CITY OF SISTERS  
PLANNING COMMISSION

STAFF REPORT AND BURDEN OF PROOF STATEMENT  
MCKENZIE MEADOW VILLAGE

**File #:** SP 15-01, MOD 15-05

**Request:** The Applicant is requesting Site Plan approval for a Senior Living Center consisting of 45 senior living units and 12 senior memory care units as part of the McKenzie Meadows Master Plan. The applicant is also requesting to modify the previously approved McKenzie Meadows Master Plan (File Nos. MP 10-01, SUB 10-02, MOD 12-01) to accommodate the Site Plan’s shifting of the location of buildings, parking and access by more than 25 feet from where they were originally approved to be located.

Proposed Master Plan Overlay Showing Changes to Previous Approved Master Plan

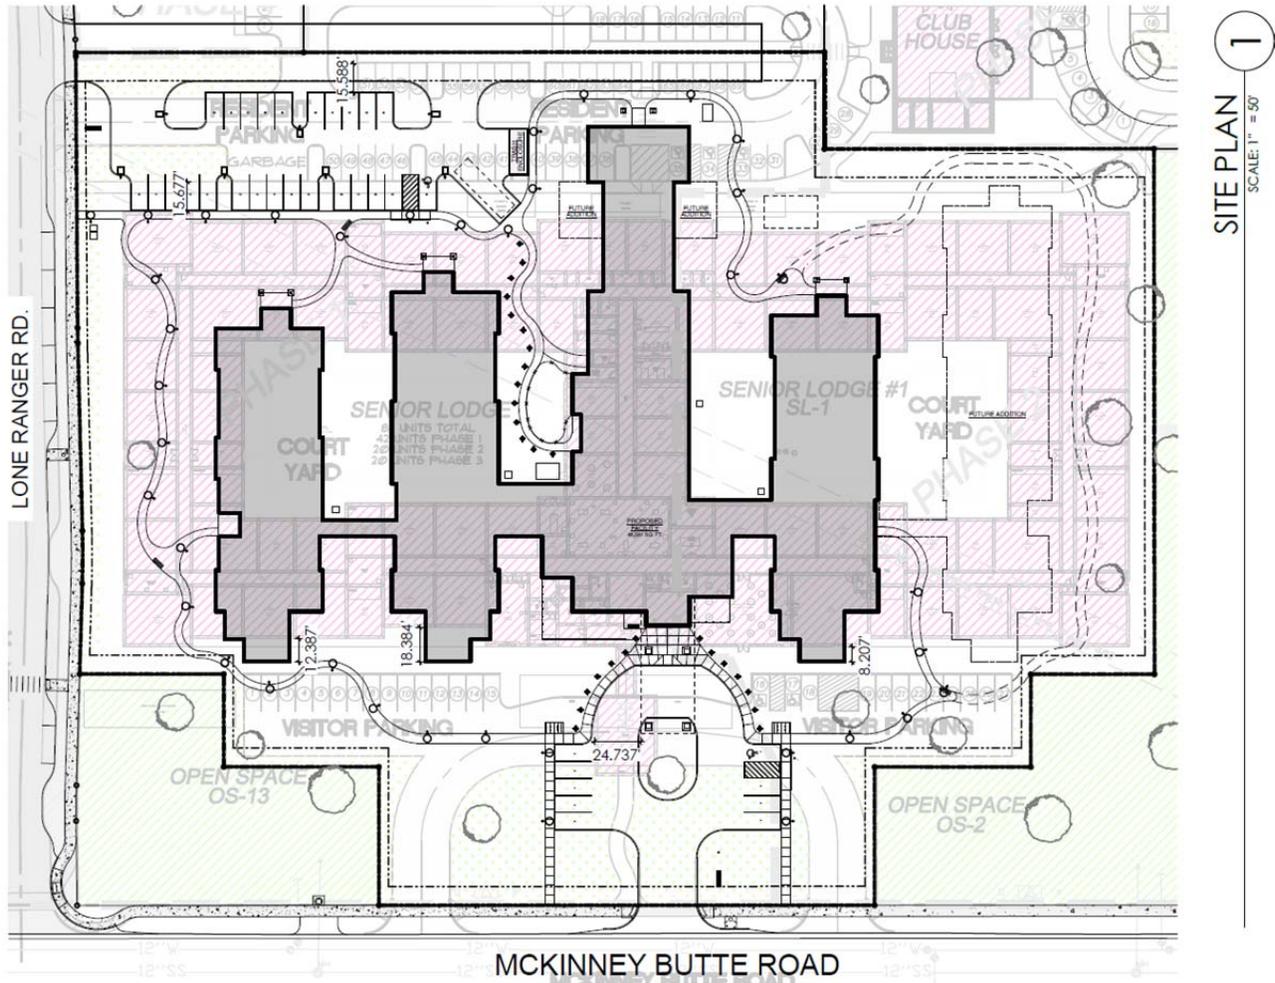
**Applicant Response:** The modification is directed specifically at building location, parking areas and access points that were depicted on the original Master Plan Exhibit. The changes are minor, they conform to the applicable development code standards, and they will not have significant additional impacts on surrounding properties. Furthermore, the modifications will not allow a greater scope or impact, thus should not be treated as an application for a new Master Plan.

**Staff Response:** The applicant is accurate in identifying the modification will not amount to a substantially new proposal or have significant additional impacts since the request is directed specifically at accommodating a site plan design in which the building location, parking areas and access points shift.
